AGENDA
CASCADE CHARTER TOWNSHIP PLANNING COMMISSION
MONDAY, November 18, 2024
7:00 PM
2870 JACKSMITH AVE SE

Public may access the meeting via video conference software Zoom

**RE: Plan Review Response MSI Surfaces Renovation
Case 24-3873 – 5085 Kraft Ave SE
Project Number: 2400360**

DRAWING INDEX - PROJECT

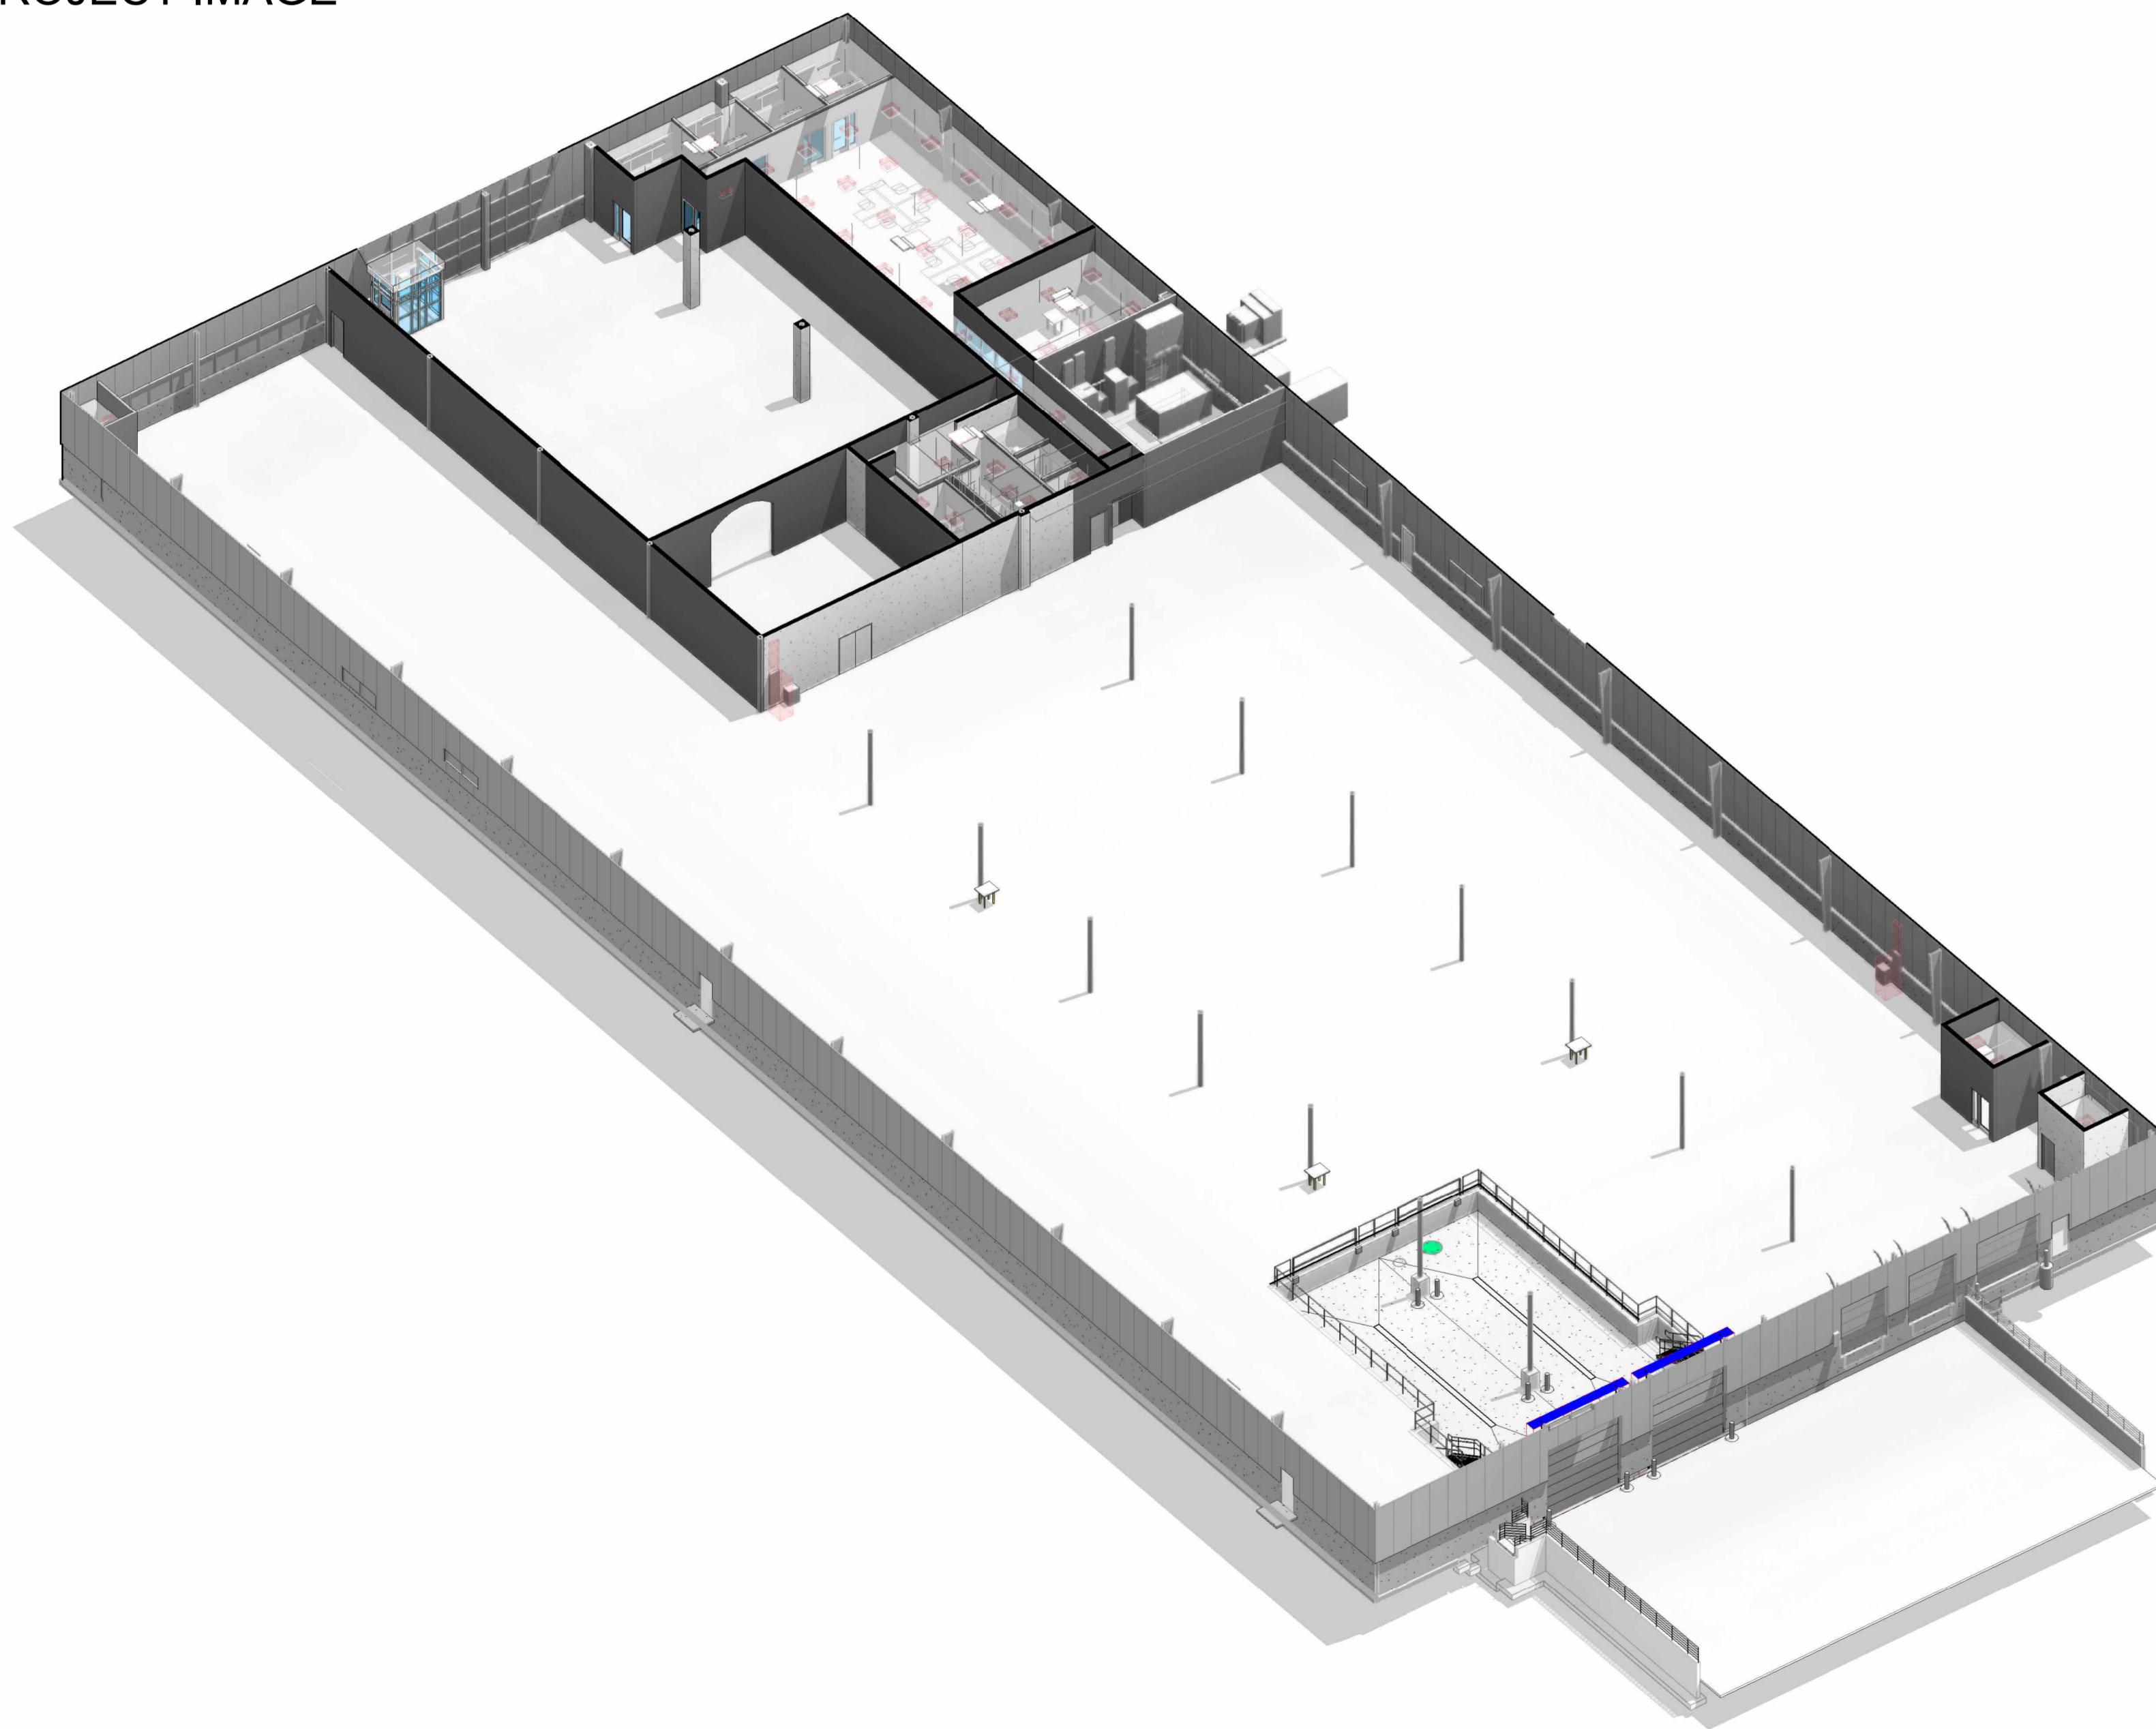
The outdoor storage of tiles and turf display area is proposed in the front of the building, facing Kraft. The tile area includes 6 pavers, approximately 96 square feet in size (each). This is a total proposed outdoor storage area of 576 square feet. The height of the outdoor storage area is 2 feet. The outdoor storage area is proposed to be located approximately 71 feet from the front property line. Section H of PUD #50 states that the outdoor storage area shall be approved by the Planning Commission. The Planning Commission shall determine the adequacy of the proposed outdoor storage area.

Response: Refer to revised drawing G00-00 – Cover Sheet clarifying the area is similar to a tiled sidewalk and decorative turf area with NO outdoor material storage.

OVERALL SITE & UTILITY PLAN

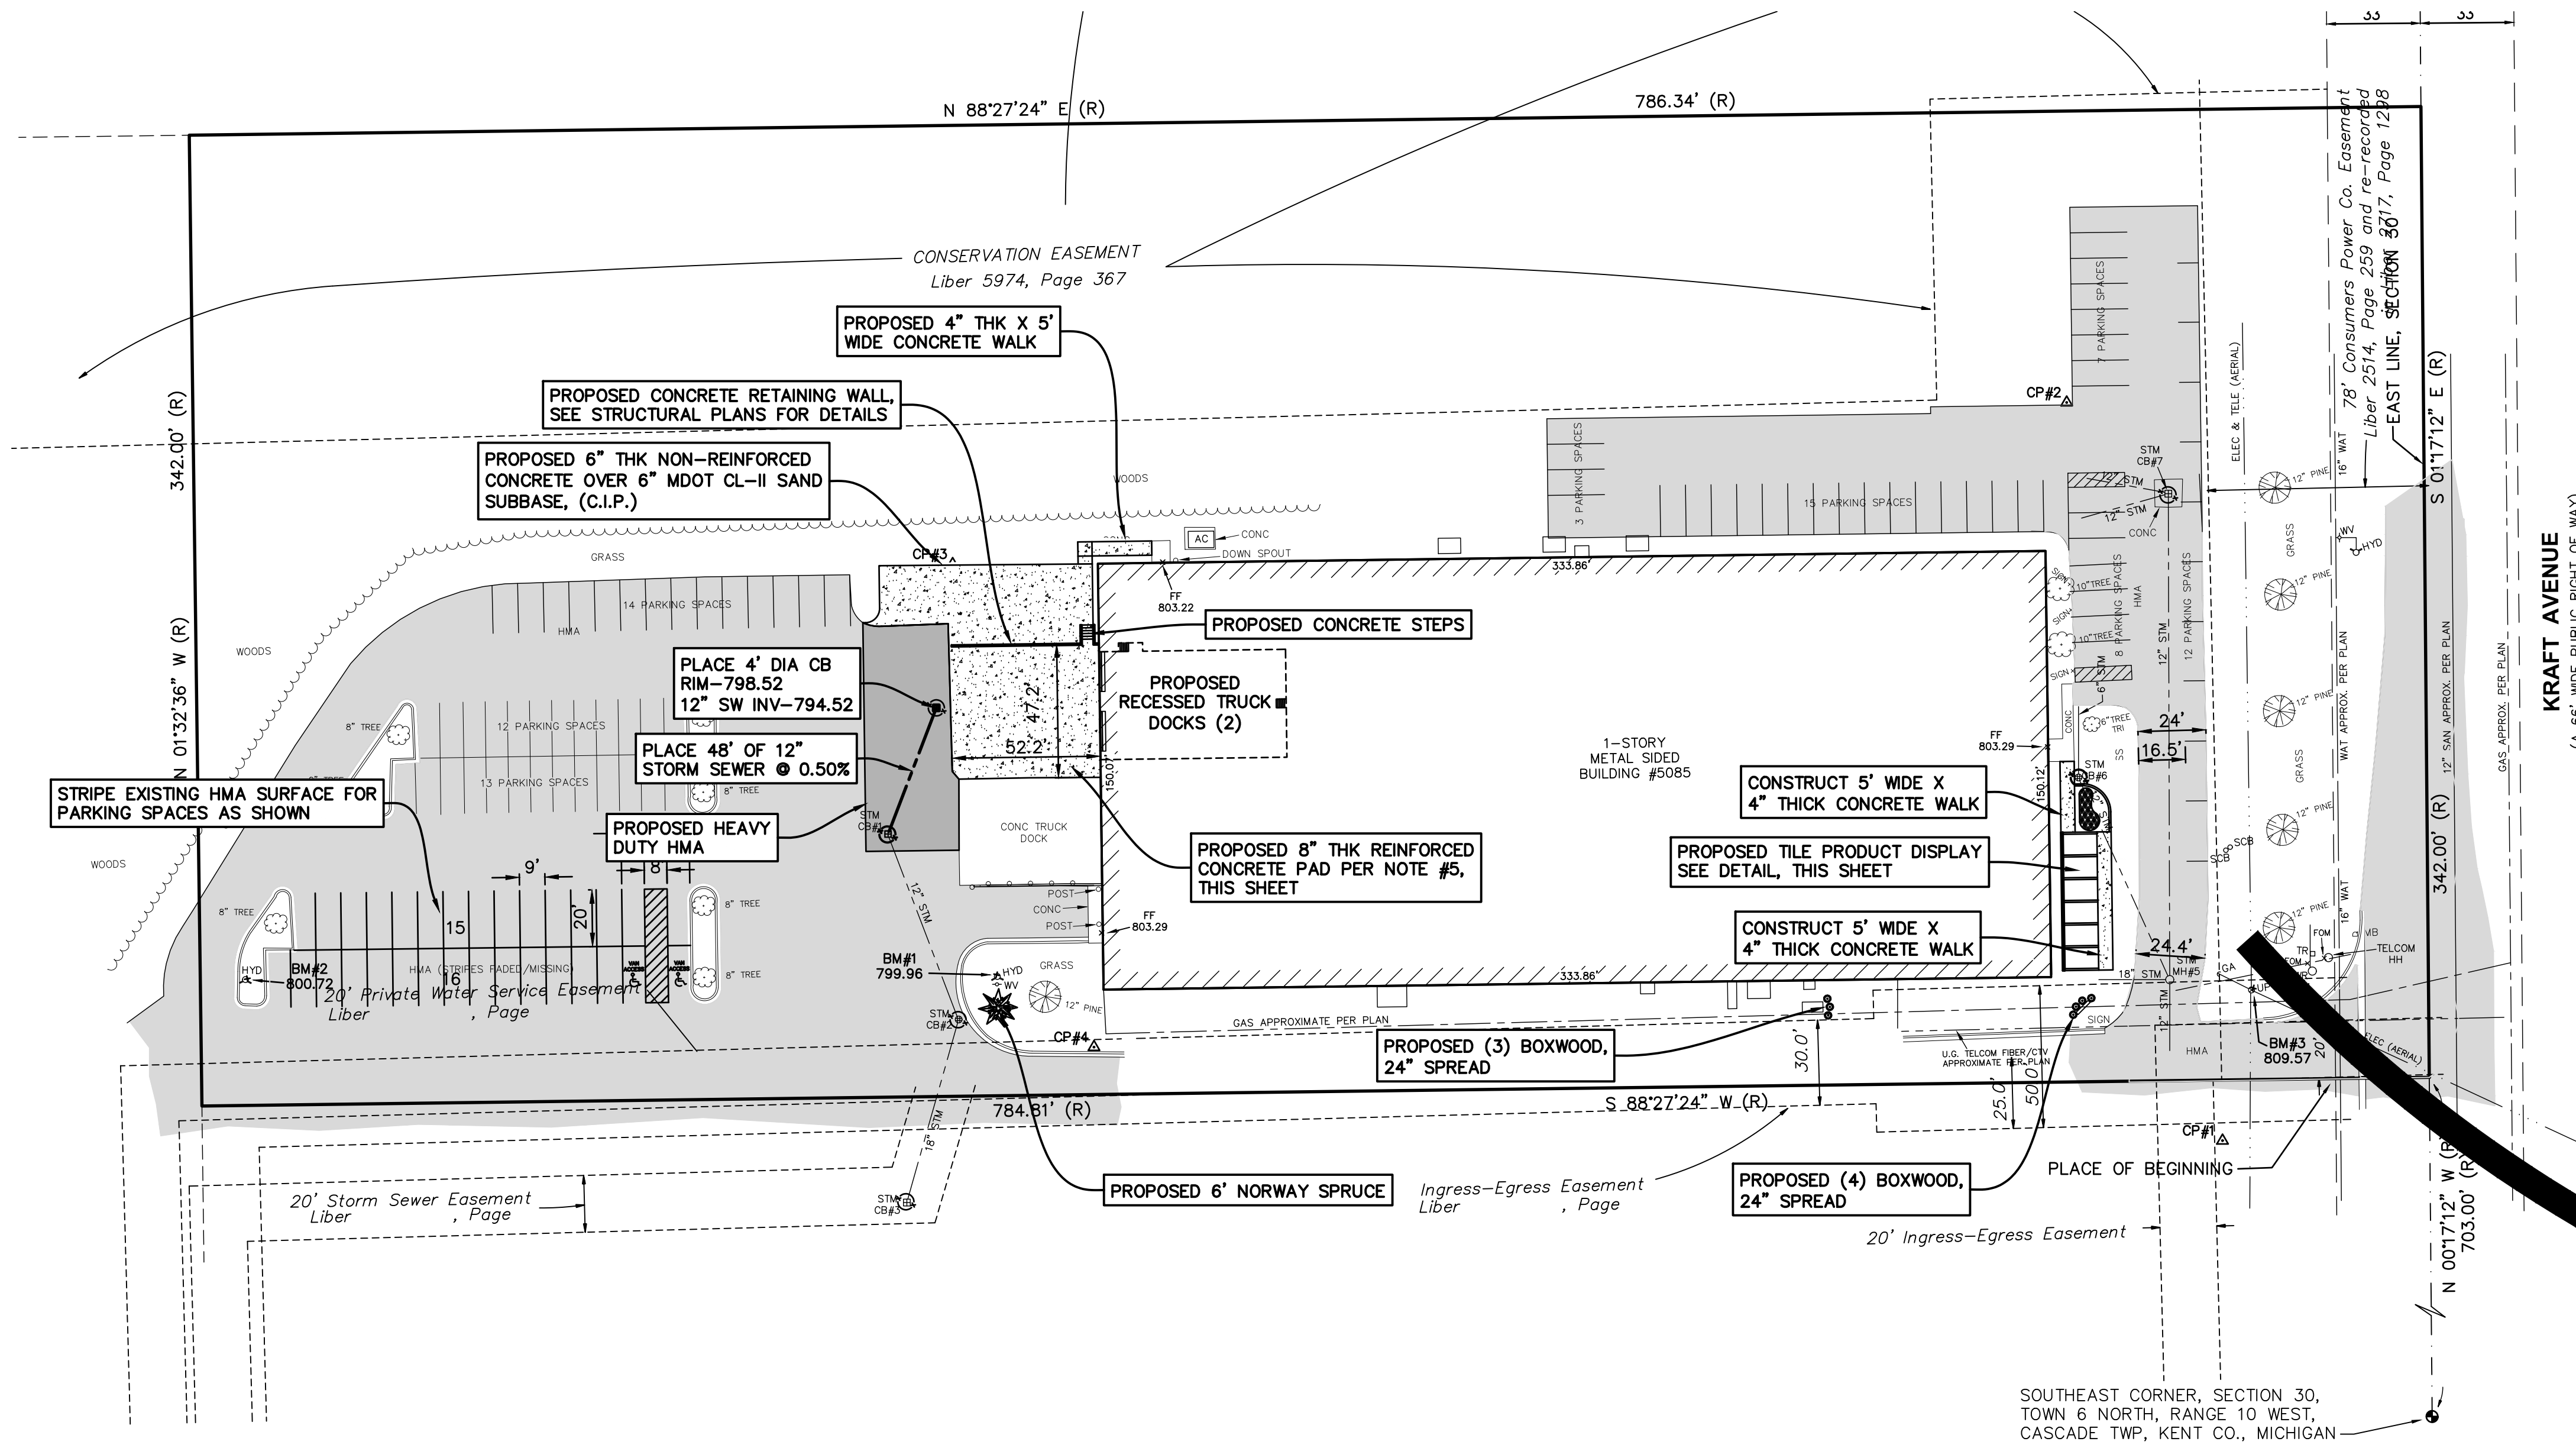
Current site conditions include a shared parking lot with the south adjacent site (5101 Kraft) and the west adjacent site (5505 Kraft). Site plans detail a total of 25 parking spaces on the west side of the building with 4 landscaped parking lot islands. Site plans also note additional spaced on the south side of the parking lot stating, “stripes faded/missing.” The parking lot shall be restriped as to clearly define each parking space in the lot and to ensure compliance with Township parking requirements.

Site plans note a proposed removal of 4 trees. A landscaping plan has not been submitted. However, given that majority of the site improvements will occur within the existing building, it is not likely that major landscaping improvements would be required, and the existing conditions may serve for the landscaping plan. Existing site conditions include a berm fronting Kraft Avenue with mature growth pine trees screening the building. We note that it is likely that the proposed landscaping conditions meet the intent of the Ordinance, given that major exterior site changes are not proposed to occur. As such, we recommend some low-profile vegetation (shrubs) to screen the HVAC area on the south side of the building to complete landscape improvements.

Response: Refer to Civil drawing 3 of 5 – Overall Site & Utility Plan with parking lot stripes indicated to be restriped to comply. In addition, the remaining parking layout is now shown to provide the full parking layout and quantity.

Response: Refer to Civil drawing 3 of 5 – Overall Site & Utility Plan with added landscaping of a 6 feet Norway Spruce and (7) Boxwoods shown along the south side of the building to provide screening of the generator and dock areas.
